SUBSURFACE WASTEWATER DISPOSAL SYSTEM APPLICATION

SUBJECT: Approval, Replacement System Variance Request, Tuttle property, Peaks Island, Portland

REPLACEMENT SYSTEM VARIANCE REQUEST

Amendment

SITE PLAN

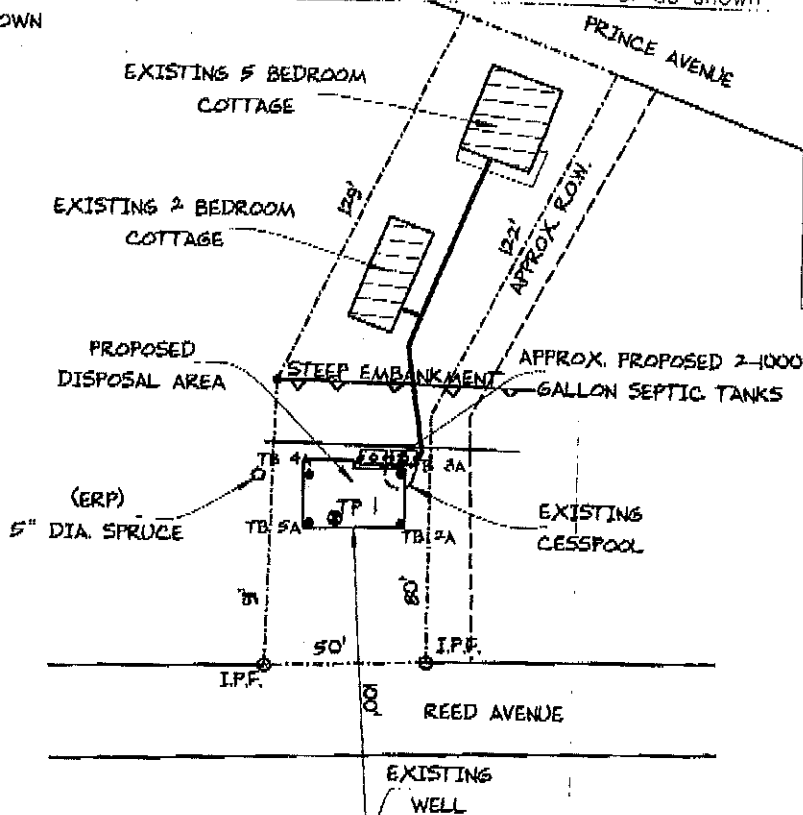
The Division has reviewed a replacement system variance request for the subject property. The state variance requested is to install the system with a setback distance reduction from a property line to the disposal field of 5 feet and to the septic tank of 4 feet, a reduction in depth to bedrock from 24 inches to 6 inches, and a fill extension graded as needed to keep the fill on the property. As we understand the situation, the variance request has been submitted because topography and existing development limit the potential system location. The system design prepared by Albert Frick, SE, dated 08/08/2005 and revised on 05/26/2006 is otherwise found to be in compliance with the Maine Subsurface Wastewater Disposal Rules.

We approve the requested variance with the following requirements:

1. A permit for system installation is to be obtained from the Local Plumbing Inspector in advance of the start of system construction.
2. The system is to be installed in accordance with the submitted and approved system design. Should alterations to the design be required at the time of construction, the site evaluator is to be notified prior to making any changes.
3. The contractor is to scarify the soils under the fill extensions to create a transitional zone more compatible with the disposal field area.
4. No fill material shall cross over the property lines unless a legal easement has been granted by the abutting property owners.
5. All surface water and water coming from the steep embankment shall be diverted away from the disposal field.
